# Administrative Action Preliminary Subdivision

**Case File / Name:** S-30-10 / Mt. Herman Road Subdivision

**SUBJECT:**  
**CROSS-REFERENCE:** S-30-10 / Mt. Herman Road Subdivision

**S-30-10 Lot Layout**

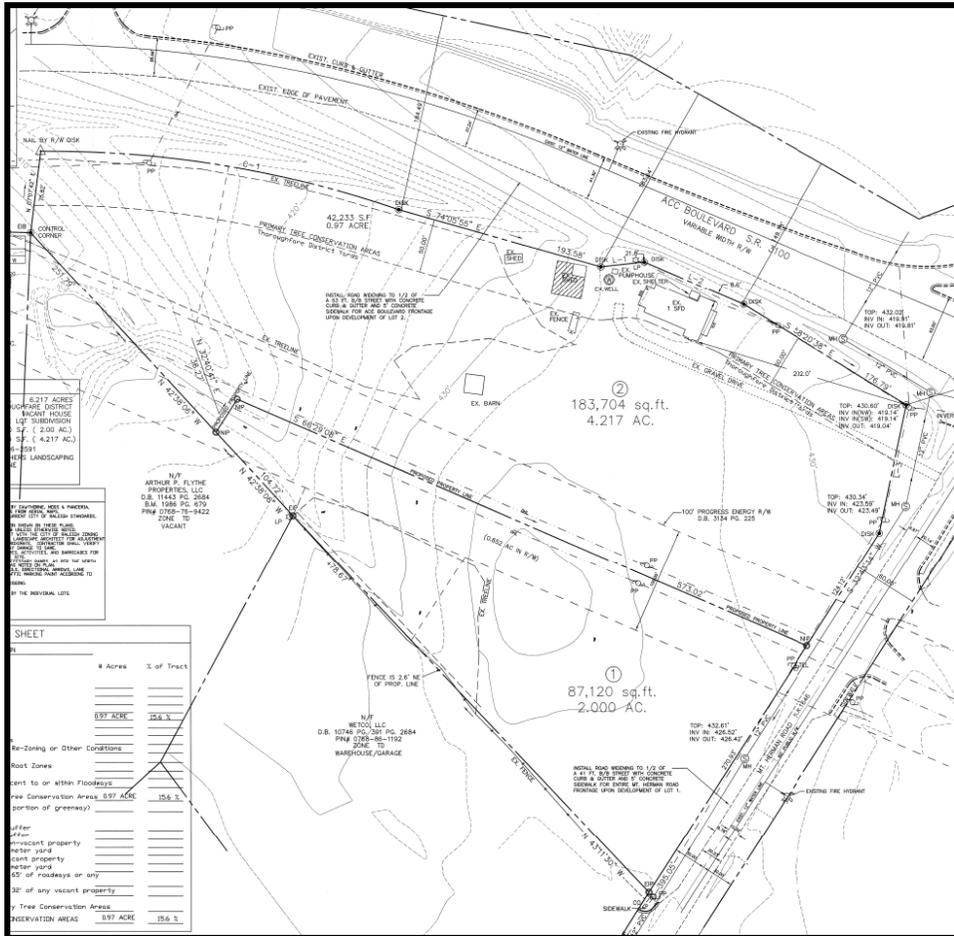
- (2) That all NCDOT driveway and / or encroachment permits must be obtained;
- (3) That as public improvements for Mount Herman Road Subdivision will be required when each lot is submitted for development, infrastructure construction will be required in the following sequence with these notes included on infrastructure construction drawings:

- a. If Lot 1 is developed prior to Lot 2, the construction of the widening of Mount Herman Road will be required as a commercial street section along the 550' of frontage for both Lots 1 and 2. Approval of the construction drawings, with traffic control and pavement marking plans, will be required prior to building permit. The widening will be ½-41' b-b curb and gutter facility with 5' sidewalk;

- b. If Lot 2 develops prior to Lot 1, the construction of the widening of ACC Boulevard and Mount Herman Road will be required. ACC Boulevard will be constructed as a minor thoroughfare section, 1/2 -53' b-b curb and gutter section with sidewalk along the 930' Lot 2 frontage. Mount Herman Road will be constructed as a commercial street section, ½-41' b-b section with sidewalk along the 550' frontage. Approval of the construction drawings, with traffic control and pavement marking plans, will be required prior to building permit. ACC Boulevard construction may require coordination (data and /or construction) with an adjacent proposed development west of this property on ACC Boulevard;
